SERVICE BULLETIN

Model: 14/20RES/L, 14/20RESA/L and 48RCL

Subject: Recent Controller Updates and Engine Hunting Troubleshooting Tips

Figure 2 Fuel Regulator Vent Tube Installation

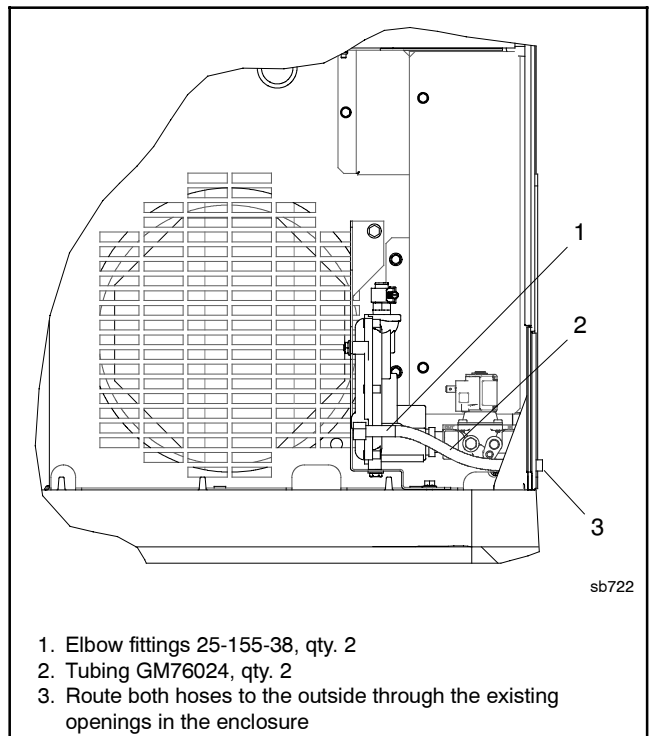
1. To prevent automatic starting, disconnect the ATS by disconnecting PWR and COM (RXT) or engine start leads 3 and 4 (RDT).
2. Confirm under what conditions the generator hunts. No load? Loaded? Only during exercise?
3. Most hunting cases can be solved by completing the following two steps:
 - a. Update to the most current version of firmware available (4.09 or higher for the RDC2, RESA/RESAL; 3.15 or higher for the RDC, RES/RESL). The Kohler Generator Service Department will provide the most current version if it is not yet available on TechTools.
 - b. Install vent tubes on the two reference ports on the fuel regulator. Procure the parts shown in Figure 1 locally, or order Regulator Vent Tube kit GM87489. Route both tubes to the outside through the customer connection openings in the enclosure. See Figure 2.

Figure 3 Trimming the Carburetor Gasket

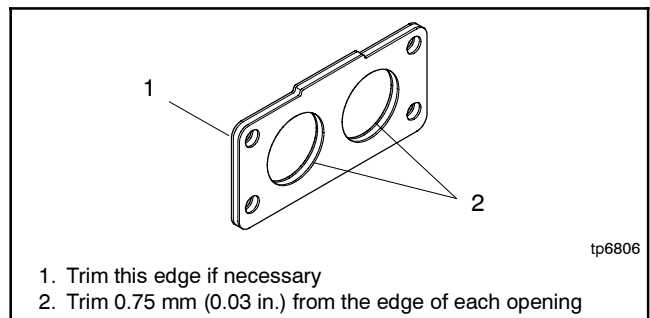
13. Are the bushings worn, causing excessive movement of the linkage?
 - a. Yes? Replace the bushings.
 - b. No? Proceed to the next step.
14. Is the carburetor gasket interfering with the throttle plate or linkage?

- a. Yes? Always trim the carburetor gasket and test the operation before replacing the carburetor. See Figure 3.

Note: Engines with serial numbers 4223605221 or higher have a new carburetor gasket that does not require trimming.
